Aviation Project Review Note for Wood Group UK Ltd Mynydd Carn y Cefn Wind Farm

Our Reference: WPAC/025/22

Initial Project Review Feasibility - Briefing Note re Mynydd Carn Y Cefn Wind Farm

For Mynydd Carn y Cefn
Wind Farm Development

Figure 2

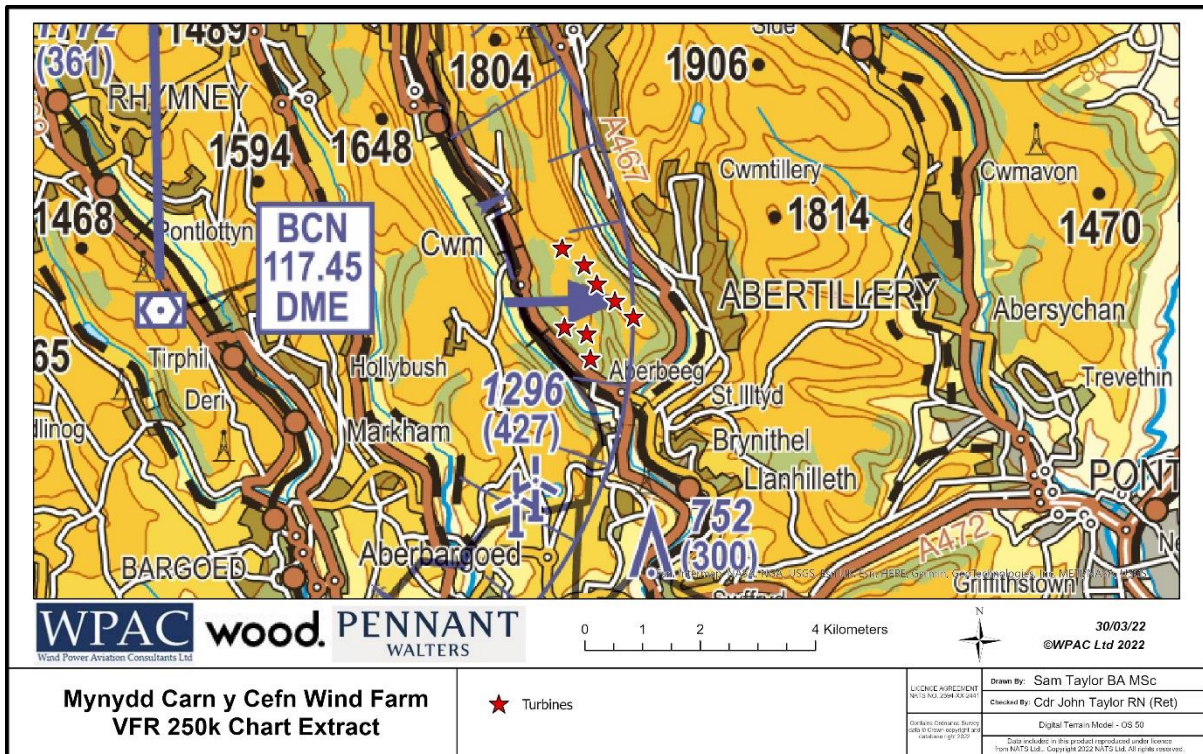
- The site is located as shown in Figures 1 to 4. Figures 2 to 4 show the location in an aviation context with Figures 2 and 3 showing the airspace up to 5000ft and Figure 4 up to 19500 ft. The site is approximately 40km to the north of Cardiff Airport and as shown in Figure 2 is 7km to the east of the Brecon (BCN) VOR/DME radio navigation beacon. Figure 4 shows the site is underneath Class A controlled airspace and is at the confluence of two busy airways taking traffic east/west from London to the Atlantic and Ireland and north/south taking traffic from Manchester/Scotland to Spain and France.

Figure 1: Proposed development location shown on an airways chart – Cardiff

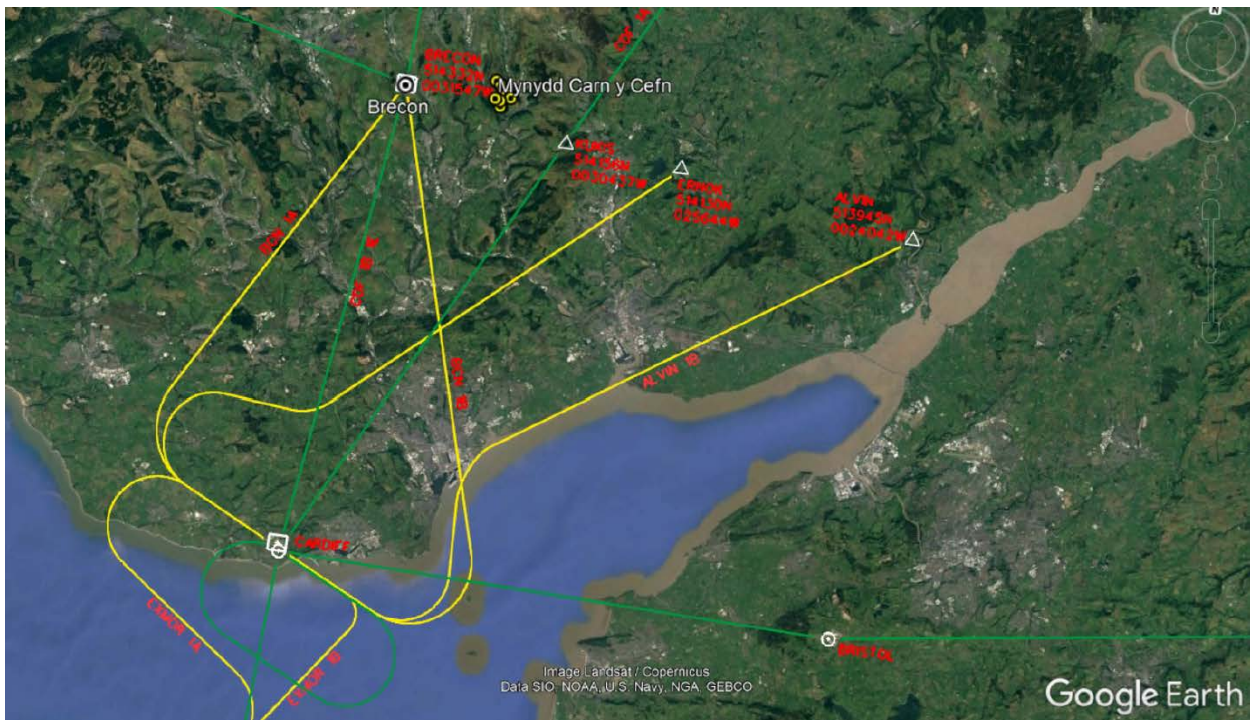
Using the theory as described in Appendix A and development specific propagation profile it has been determined that the terrain screening available will not adequately attenuate the signal, and therefore this development is likely to cause false primary plots to be generated. A reduction in the RADAR's probability of detection, for real aircraft, is also anticipated.

The proposed wind farm is sited in an area that is very popular with VFR traffic often on navigational exercises between west Wales and England as well as local traffic from Cardiff and St. Athan who will be on our LARS frequency.

In addition to the issues described above it is also sited beneath airway Q63. A strong primary radar return in this location could lead to ATCOs believing there to be an infringing aircraft and therefore taking avoiding action, or become too familiar with the returns and potentially not detect an infringing aircraft believing the return to be the wind turbines and therefore not issuing avoiding action when they should have done.

The proposed development has been examined by technical and operational safeguarding teams. A technical impact is anticipated, this has been deemed to be unacceptable due to the impact on the operation at Cardiff Airport.

Figure 2: Proposed development location shown on an airways chart - Bristol

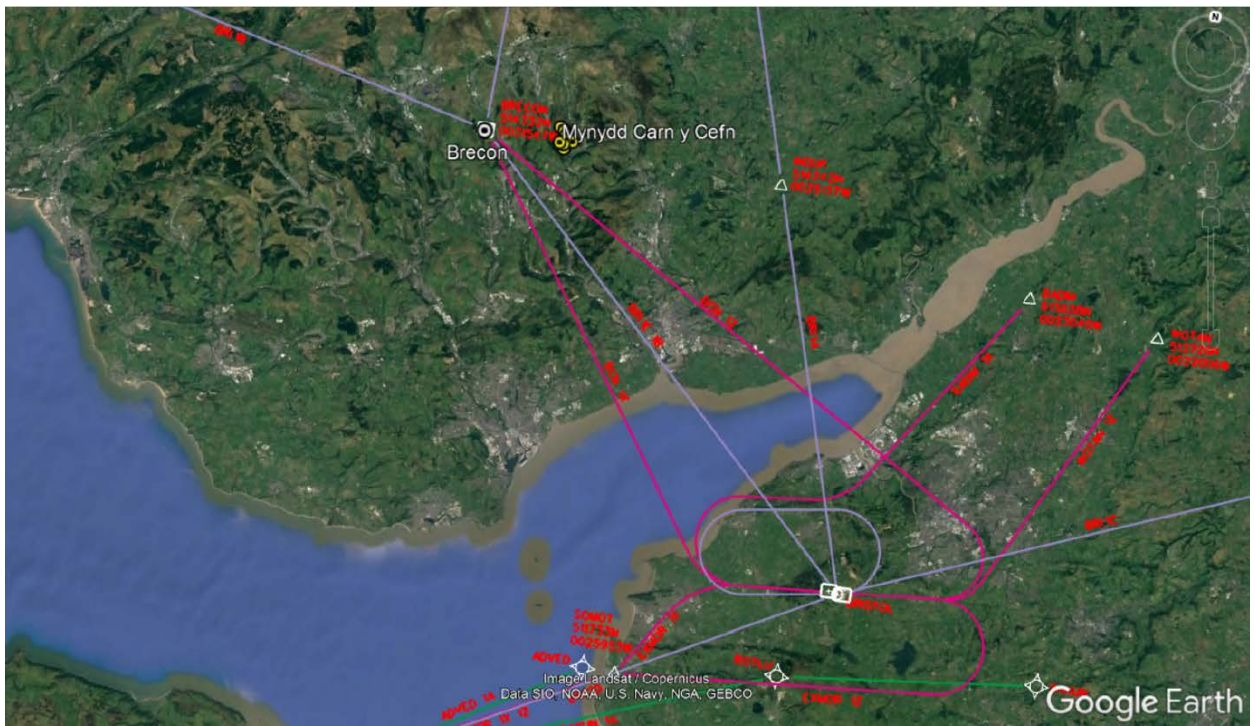
Using the theory as described in Appendix A and development specific propagation profile it has been determined that the terrain screening available will not adequately attenuate the signal, and therefore this development is likely to cause false primary plots to be generated. A reduction in the RADAR's probability of detection, for real aircraft, is also anticipated.

No operational impact expected.
